Comments on the 802.3dm Complexity and EMC performance

July 28, 2025

Ahmad Chini, Mehmet Tazebay
Broadcom

The Claim on TDD and ACT Receiver Complexity versus FDD¹

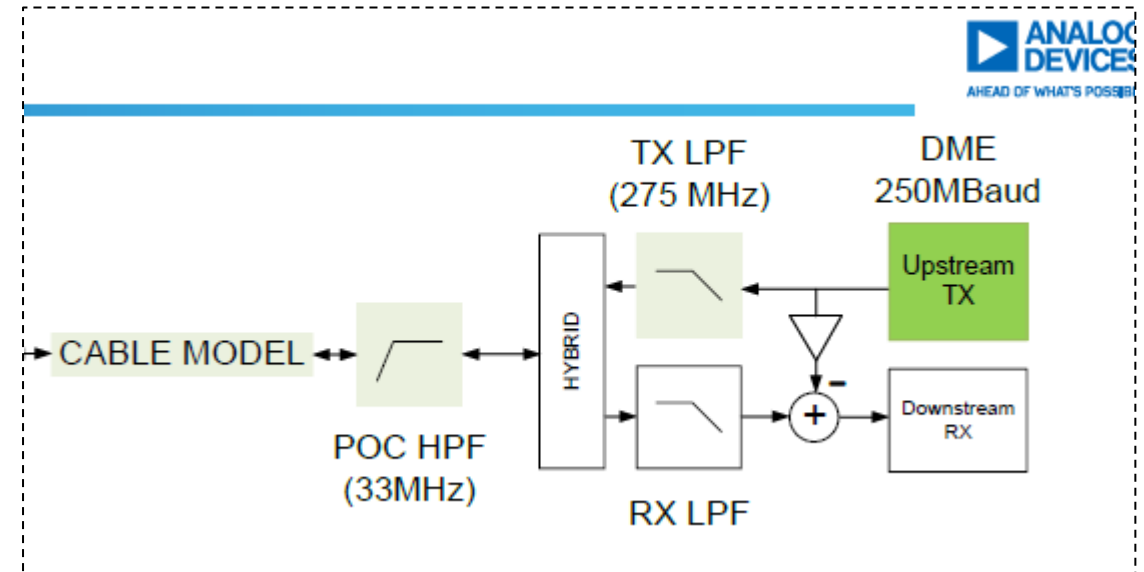
- This earlier presentation¹ claimed that the receiver complexity is 250% larger in the camera side for TDD and 200% larger in the ECU side for ACT.
- The suggested block diagram for FDD¹ receiver is shown in the next two pages with comments.

FDD¹ Receiver Block Diagram, Low Speed Side

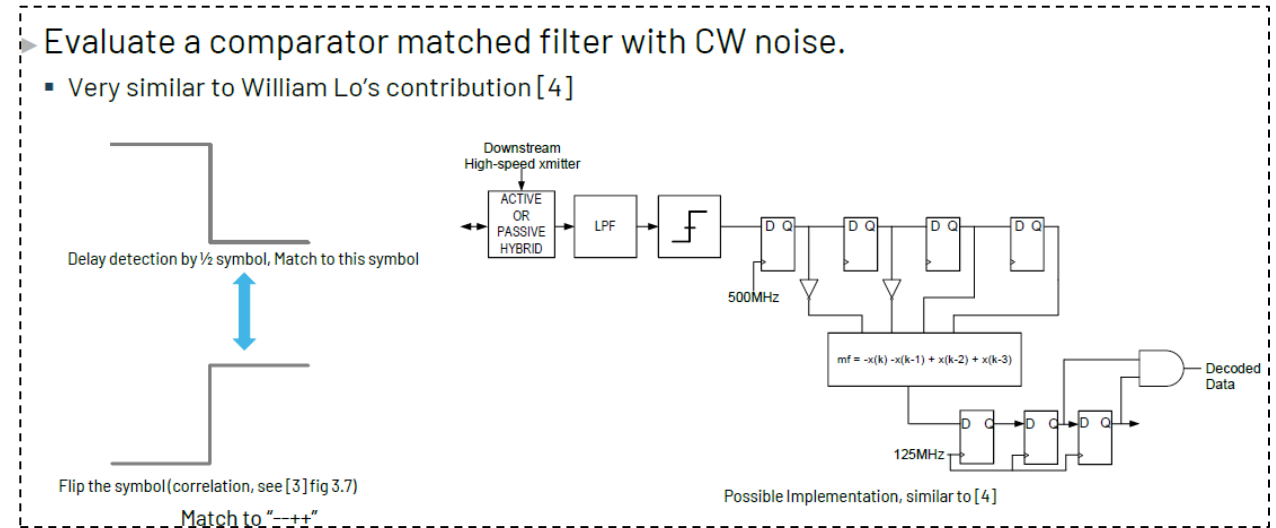
- For low-speed side, the receiver block diagram used for complexity comparison is like an earlier presentation² where area is estimated to be 0.012mm².
- The LPF is a 2nd order Butterworth.
- Sampling Clock is 500MHz.
- Clock frequency and phase synchronization and tracking is not addressed in this implementation. The phase interpolator to tune clock phase and frequency is missing in the diagram.

TDD Equalizer Area on the Camera Side

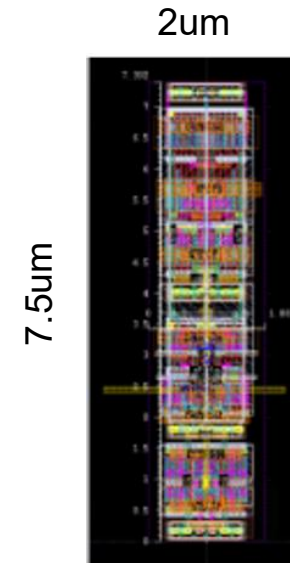
- Two equalization formats have been discussed¹ for TDD.
 1. CTLE + VGA + DFE + Slicer
 2. CTLE + Slicer
- For the upstream, TDD signal baud rate is 3Gbps and duty cycle is less than 6%. The processing rate is only **175Mbps** including the refresh period (as compared to **500Mbps** for FDD¹).
- A **10G SerDes PHY** in 16nm used to estimate area for TDD equalizer area.
- SerDes design experts suggest only 30% to 40% reduction in area when running in 3Gbps.
- The following blocks considered in the estimation to calculate the total area of **0.0108mm²** for 3Gbps analog equalizer.

Note: Calibration and phase interpolator is missing from the suggested FDD receiver.
